Access Compliance Report Public Rights-of-Way (Curb Ramps)

Main Street: N/A Cross Street: CROWN_VALLEY_PKWY Location: S

ADA ID: RPRK211201113712 Ramp Type: Type 1 - Perpendicular Diagonal Initial Pass/Fail: Fail Overall Compliance: No Severity Score: 60

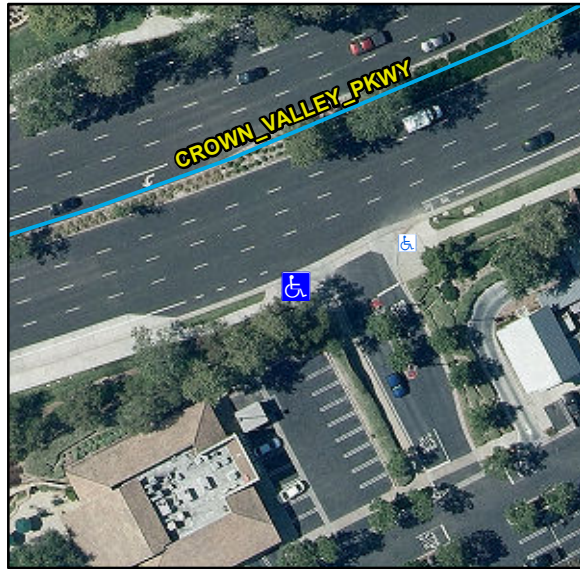
Compliance	Description	Data	Compliance	Description	Data
N/A	Ramp Length (in)	117	N/A	Flare Type LT	
Yes	Ramp Width (in)	48			N/A
No	Ramp Run Slope (%)	13.9	N/A	Flare Slope LT (%)	N/A
No	Ramp Cross Slope (%)	8.5	N/A	Flare Traversable LT	N/A
N/A	Landing Present	N/A	N/A	Flare Type RT	
N/A	Landing Length (in)	N/A			N/A
N/A	Landing Width (in)	N/A	N/A	Flare Slope RT (%)	N/A
N/A	Landing Run Slope (%)	N/A	N/A	Flare Traversable RT	N/A
N/A	Landing Cross Slope (%)	N/A	N/A	DWS Provided	N/A
N/A	Landing Movement Obstructed?	N/A	N/A	DWS Contrast	N/A
	Landing Movement Type	N/A	N/A	DWS Length (in)	N/A
N/A	Landing Shared	N/A	N/A	DWS Full Width	N/A
N/A	Clear Space	Yes	N/A	DWS Offset Left (in)	N/A
N/A	Clear Space To Crosswalk (in)	N/A	N/A	DWS Offset Right (in)	N/A
N/A	Marked Crosswalk 1	No	N/A	Marked Crosswalk 2	No
	Crossing 1 Direction	E		Crossing 2 Direction	N
	Marked Crosswalk 1 Width (in)	N/A		Marked Crosswalk 2 Width (in)	N/A

N/A	Ramp Inside Crosswalk 1	N/A	Yes	Ramp Inside Crosswalk 2	N/A
	Crossing 1 Slope (%)	14.1		Crossing 2 Slope (%)	2.3
	Crossing 1 Cross Slope (%)	6.4		Crossing 2 Cross Slope (%)	6.3
N/A	Gutter Ponding	N/A	No	Curb Slope	11.1
Yes	Gutter Lip Height (in)	0		Road Run Slope (%)	7.6
N/A	Gutter Run Slope (%)	N/A		Road Cross Slope (%)	1.6
N/A	Gutter Cross Slope (%)	N/A			
Yes	Overall Surface Condition: Acceptable		No	Perp Joint Present	No
	Cross Gutter Present?	Yes		Spandrel Present?	Yes
	Replace Cross Gutter?	No		Replace Spandrel?	No

Remove & Replace Curb Ramp With Two New Directional Ramps or Equivalent.
